Change Notice

CN-0041

Epoxy Seal at Base of Terminals

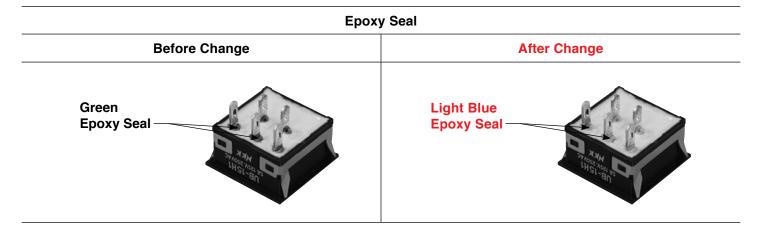
The epoxy seal material at the base of the UB and UB2 Series terminals is changing. The new light blue epoxy seal will replace the current green epoxy, and improve the strength of the terminals at the base.

UB and UB2 Series changes to epoxy seal will be effective with December 2009 production.
